RS-15-129

Subject: Response to Request for Additional Information Regarding Request for a License Amendment to Braidwood Station, Units 1 and 2, Technical Specification 3.7.9, "Ultimate Heat Sink"

Response to Request for Additional Information

RATIO OF EFFECTIVE TO CROSS AREA FOR LAKES OF VARIOUS LENGTH TO WIDTH AND DEPTH TO WIDTH RATIOS
Figure MES-11.1-02

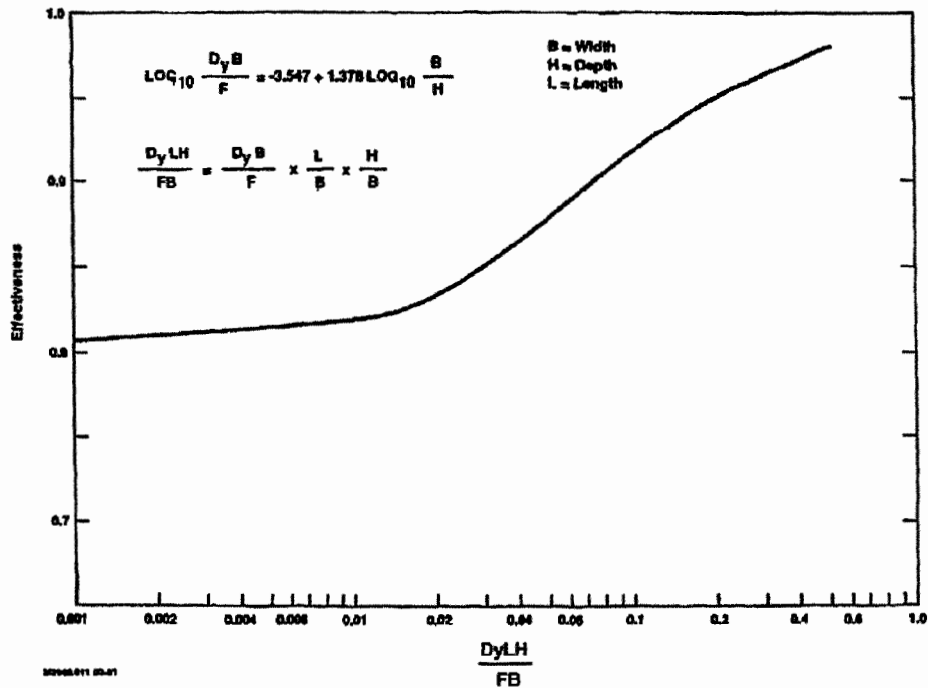
Provide justification that demonstrates that the LakeT-PC model accurately represents the effective essential cooling pond volume and surface area with sufficient accuracy and within the margin of error for the temperature of cooling water that supplies the safety related loads.

Effectiveness - Effective Area and Volume were calculated to be 82.3% of gross values. Effectiveness of the UHS was determined in Calculation MAD 83-0239. The methodology utilized for calculation of the Braidwood UHS effectiveness has subsequently been documented in S&L Engineering Guideline MES-11.1. The main inputs for lake effectiveness are the lake

size/shape and water flow. Based on figure MES-11.1-02 , presented below and as included in a response to an NRC RAI received for the LaSalle UHS temperature increase request (Reference 9), the effectiveness of the main channel varies from approximately 81 to 98%. Therefore, the value of 82.3% calculated in MAD 83-0239 is conservatively on the lower side of the curve. Note that the Braidwood UHS is a man-made rectangular shape lake without any side arms or odd shapes.
